Response to Submissions

Mona Vale Community Health Centre (SSD 6160)

Coronation Street, Mona Vale

Submitted to NSW Department of Planning and Environment
On Behalf of Health Infrastructure

Figure 3 – Reduction in building height from exhibited proposal
Source: McConnel Smith and Johnson

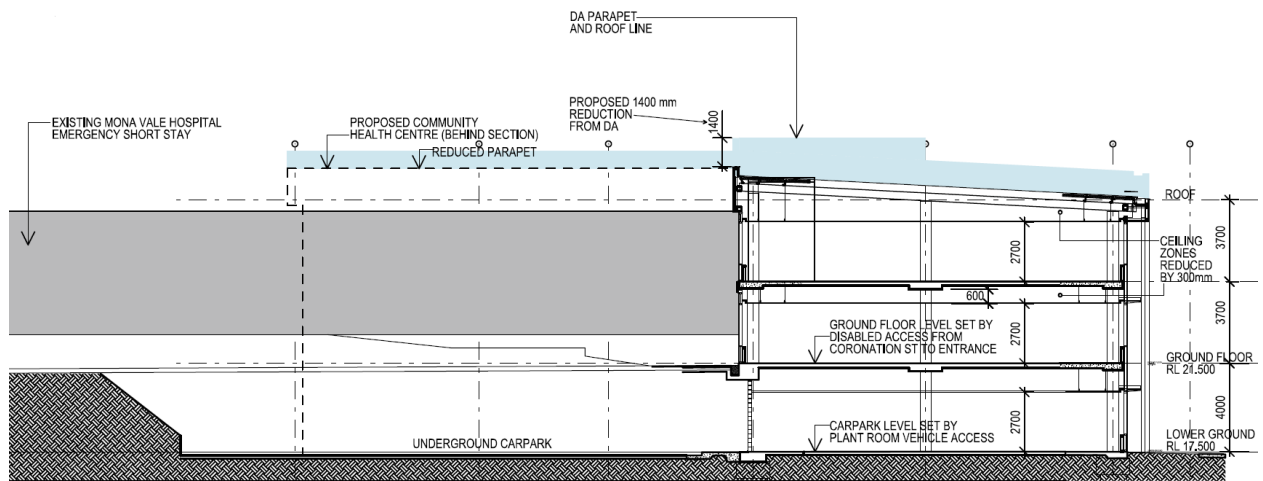
As noted in **Section 2.1** above, the maximum building height of the proposed development has been reduced by 1.4m from 14.1m (as exhibited) to 12.7m (as amended). **Figure 3** below illustrates the proposed reductions in building height in sectional form, showing the reduction in parapet height and roof form from the exhibited proposal (shown in blue).
